SUBJECT: update for floating valves VS0800218 e VS0800219

s_280.03_Vdf-Rev1

Previous version	Current version

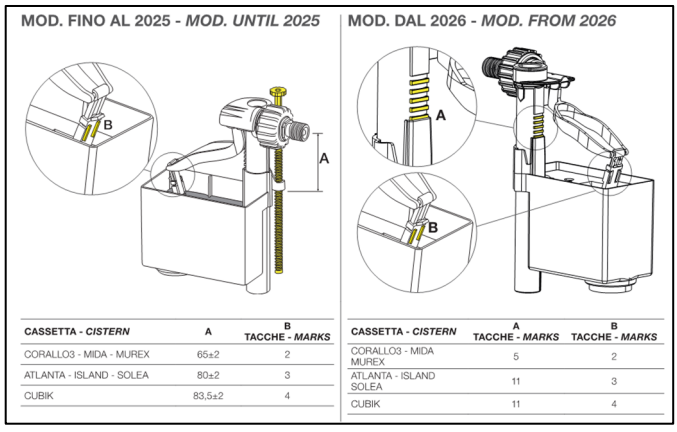
Herby we inform you that the “dual-adjustment” type float valves—supplied both in external cisterns and as spare parts—have been modified: the adjustment screw has been eliminated and replaced by a setting system using notches integrated in the vertical part and on the floating box

The water level is adjusted by moving the floating box up or down to the positions indicated by the marks (see the instruction below).

CASSETTA - *CISTERN*	A	B TACCHE - *MARKS*
CORALLO3 - MIDA - MUREX	65±2	2
ATLANTA - ISLAND - SOLEA	80±2	3
CUBIK	83,5±2	4

CASSETTA - *CISTERN*	A TACCHE - *MARKS*	B TACCHE - *MARKS*
CORALLO3 - MIDA MUREX	5	2
ATLANTA - ISLAND SOLEA	11	3
CUBIK	11	4
